Re: Limerick Generating Station Units 1 and 2  
Docket Nos. 50-352 and 50-353

LIMERICK GENERATING STATION  
PROBABILISTIC RISK ASSESSMENT

The attached pages and divider are to be inserted at the end of Volume I of the Limerick Generating Station Probabilistic Risk Assessment report.

Comparison of WASH-1400 at Limerick with WASH-1400  
(Site Effects)

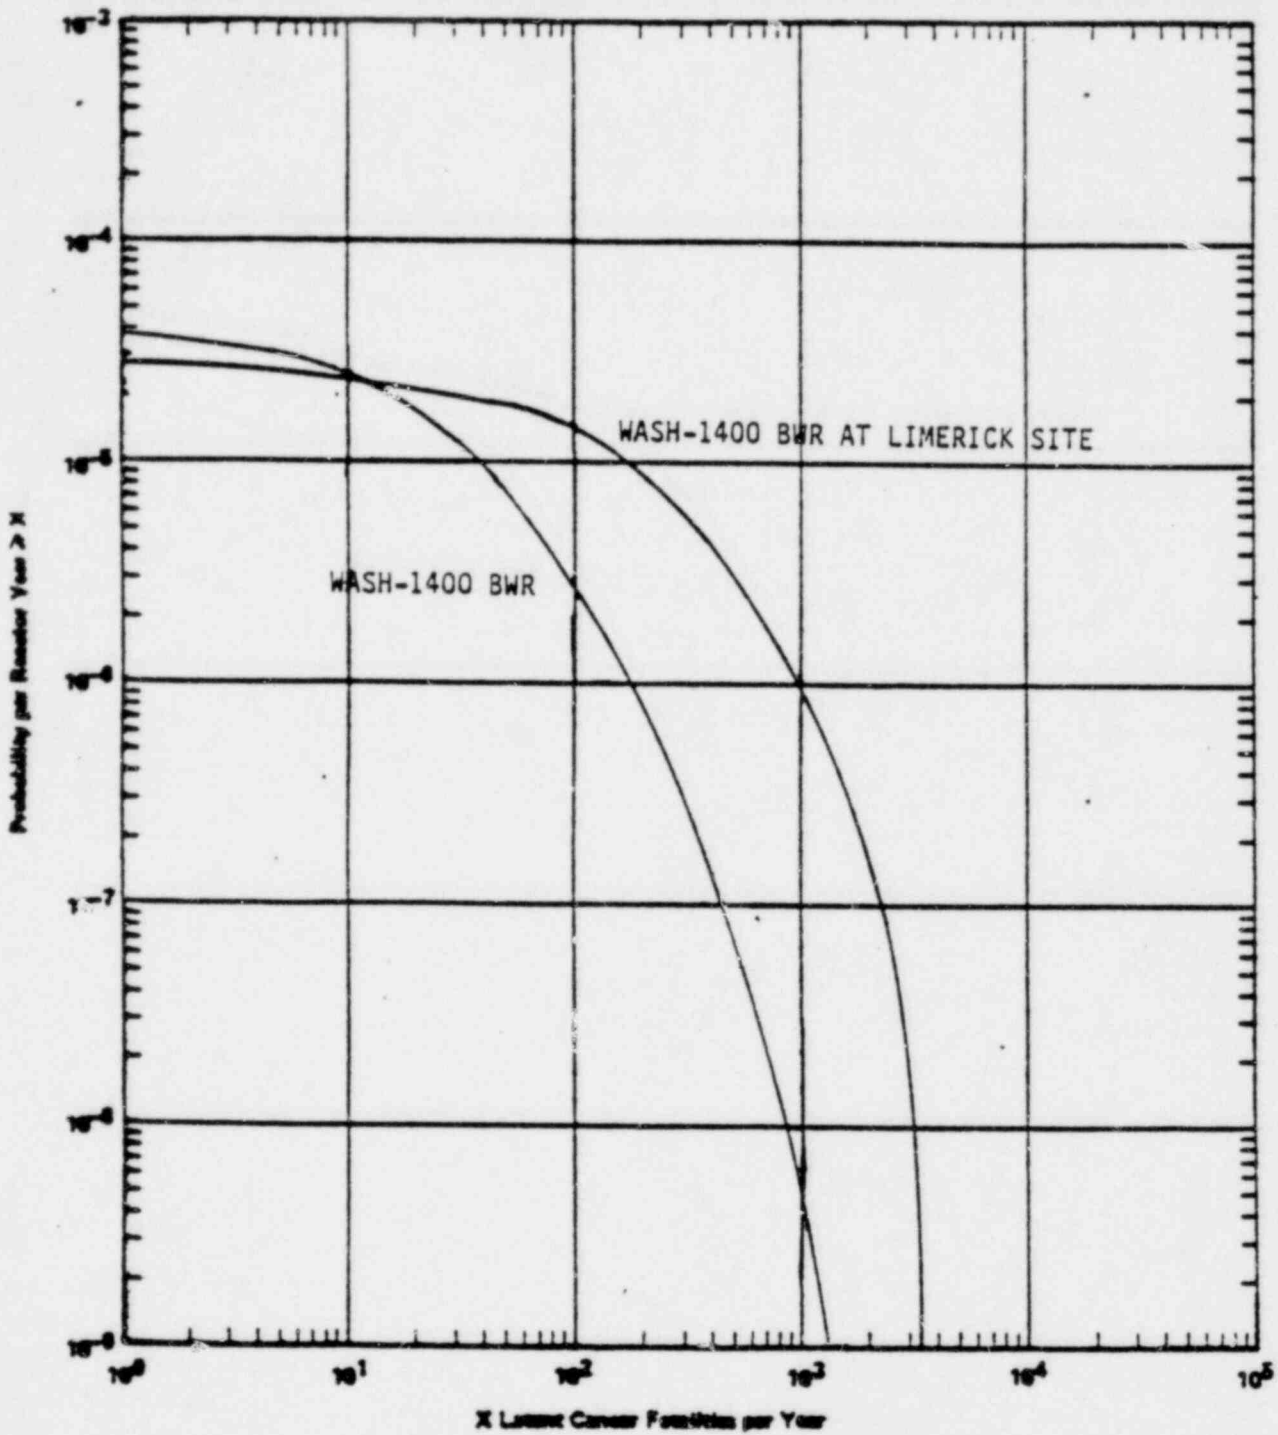
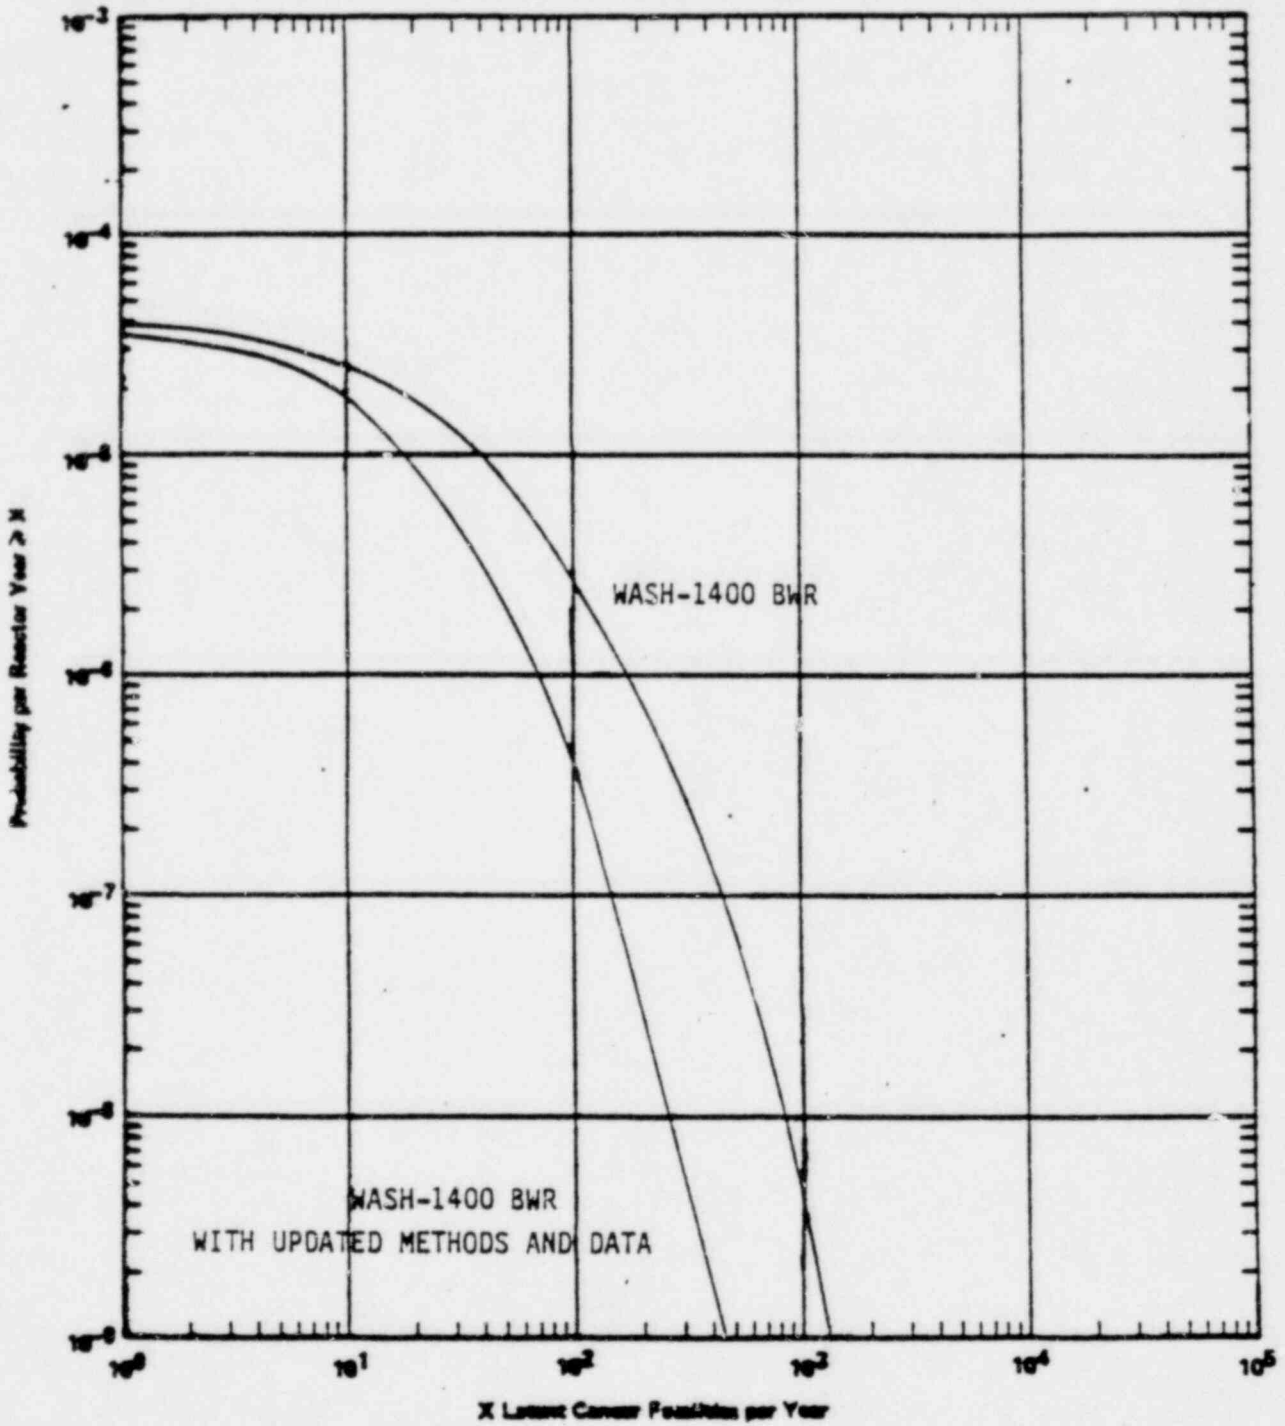
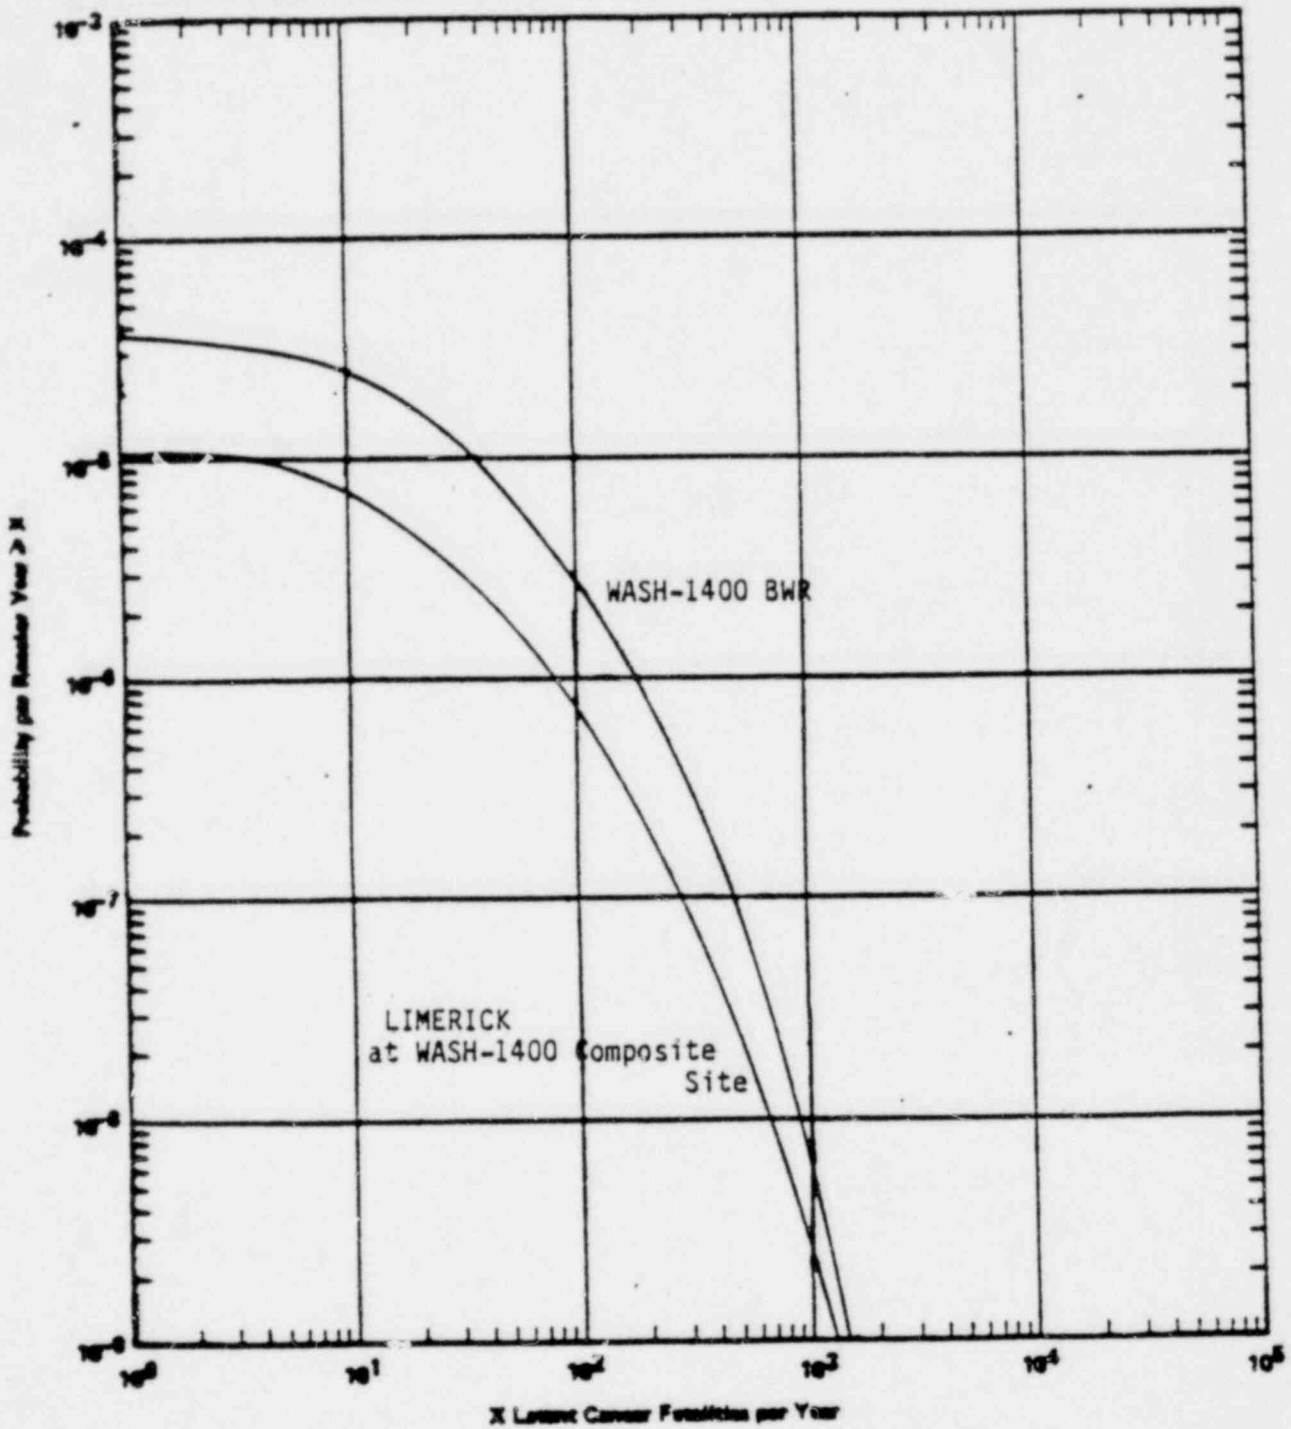
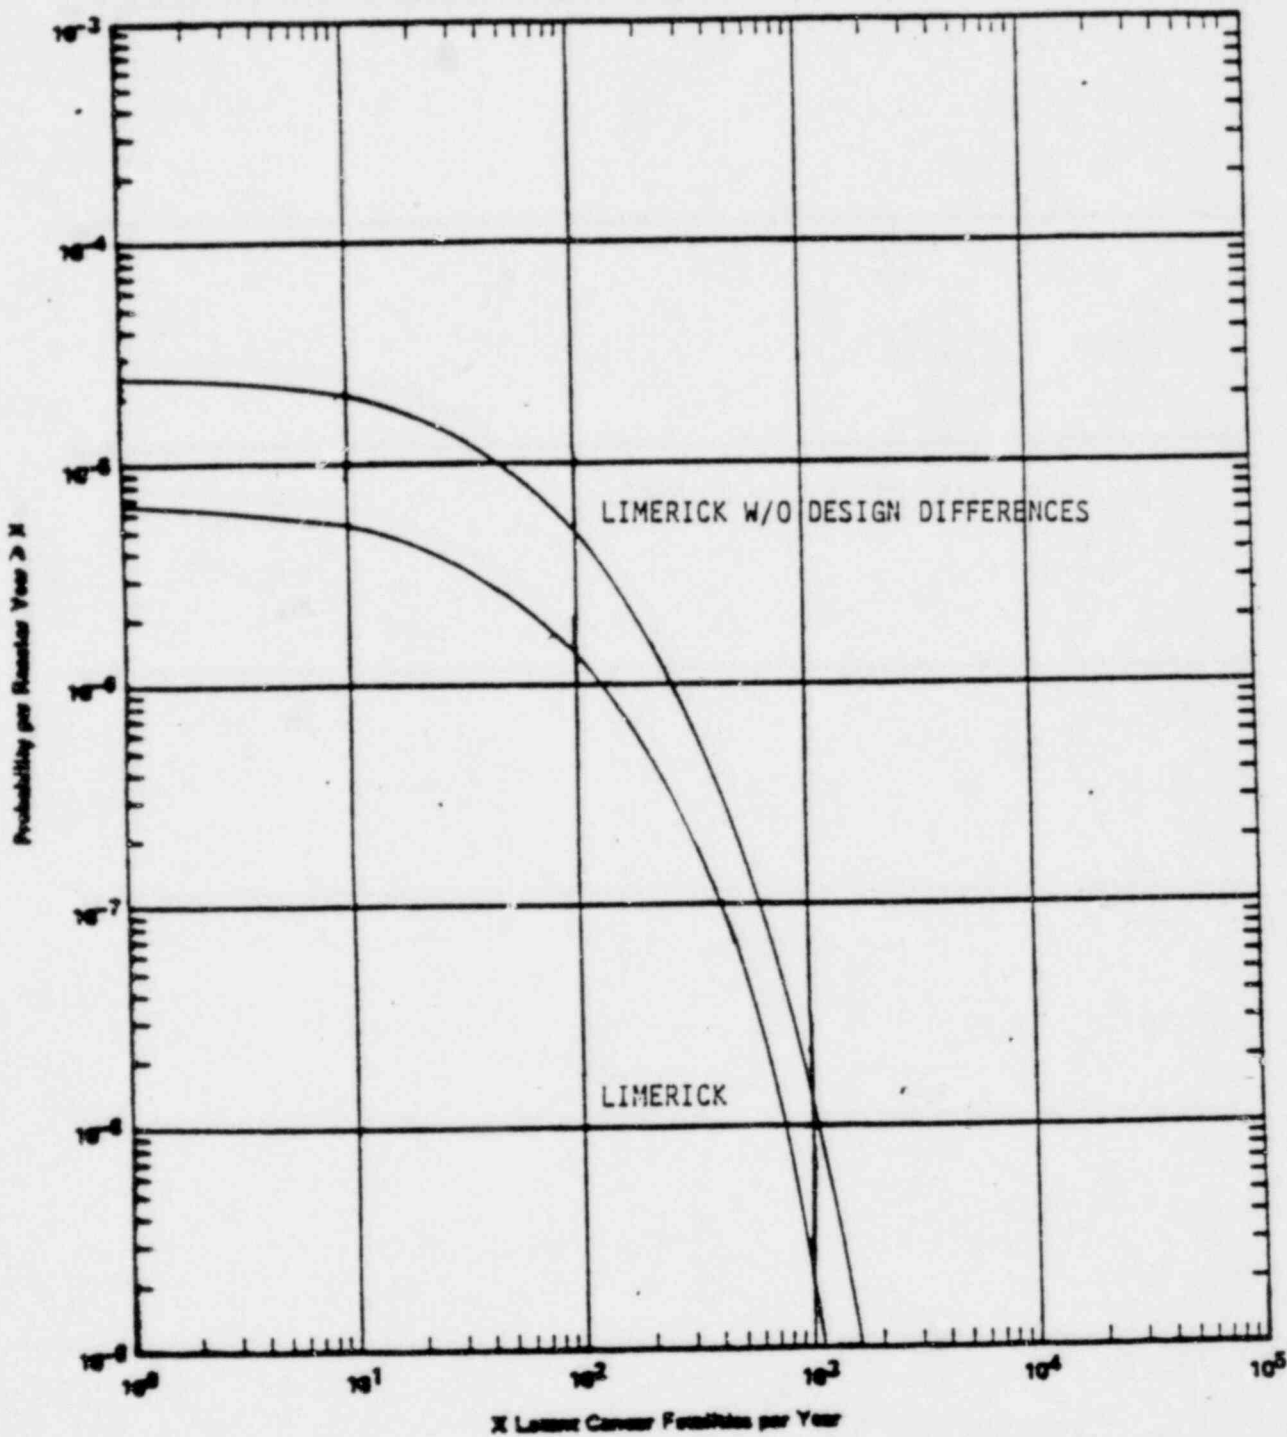
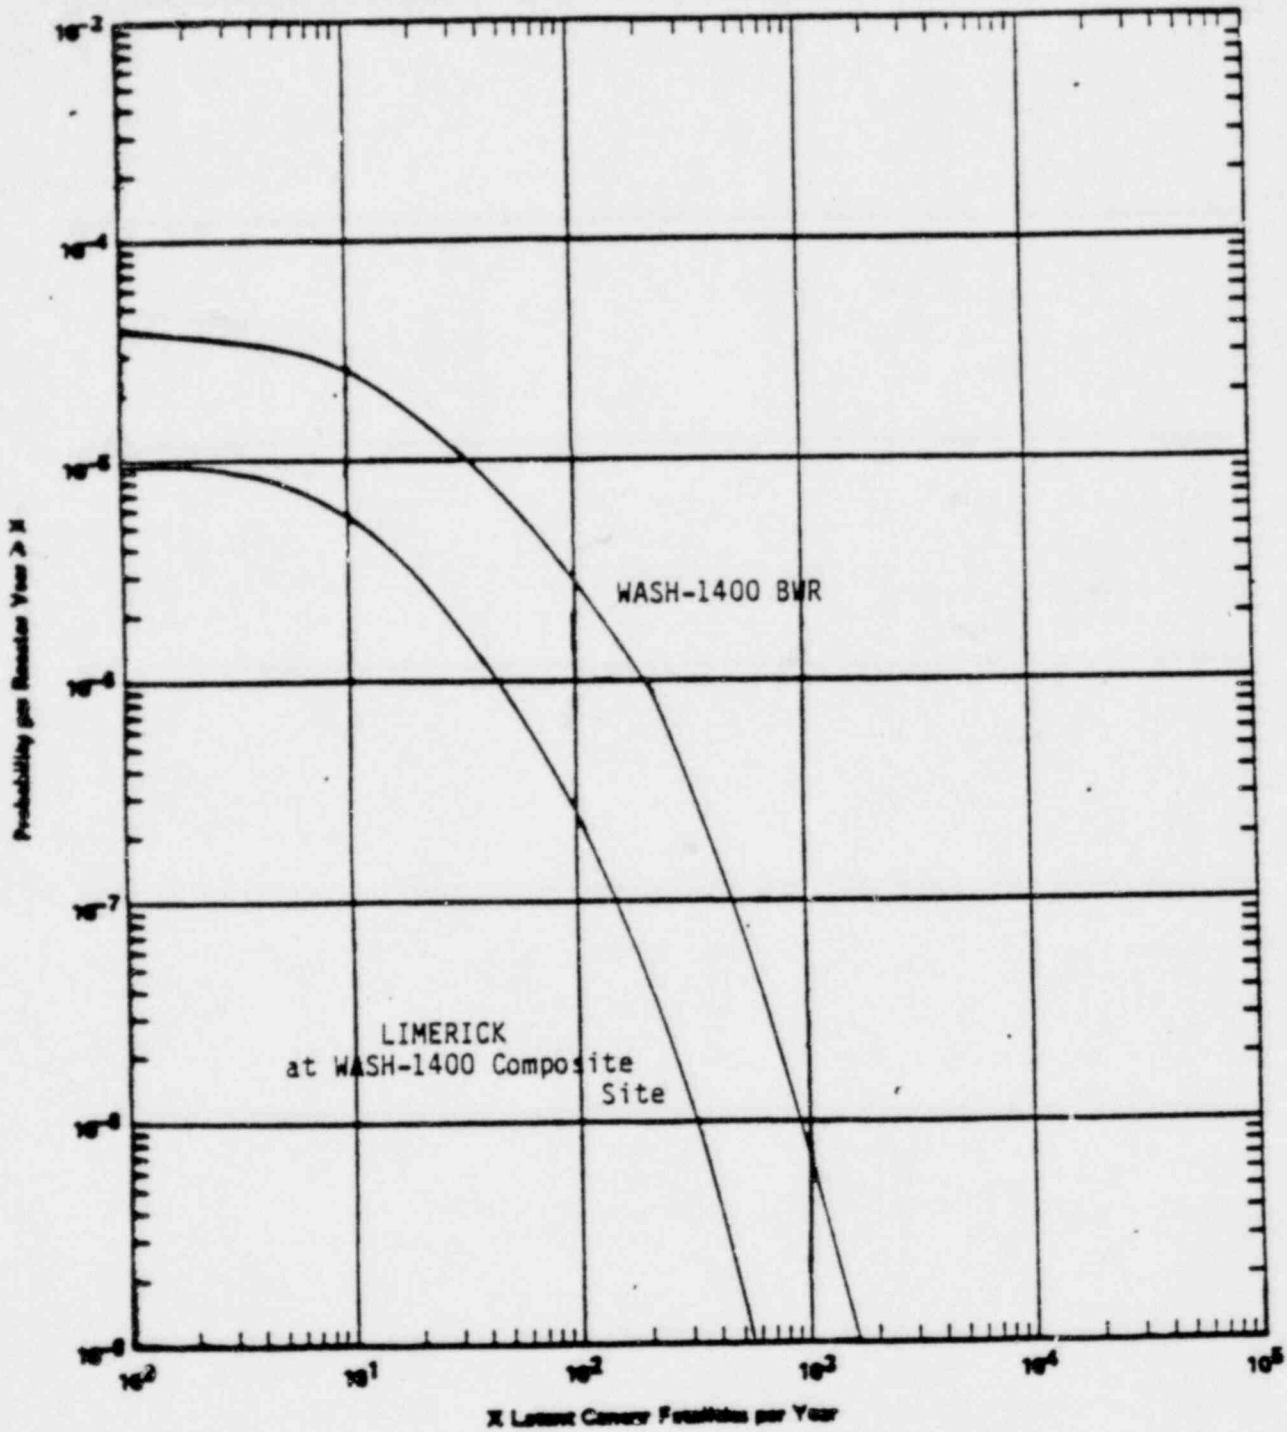
Sensitivity studies for latent cancer and property damage are needed to allow comparison with WASH 1400 results based on design and site differences only.

Sensitivity information on latent cancer is shown on the attached figures. The information on property damage will be supplied during the fourth quarter of 1981.
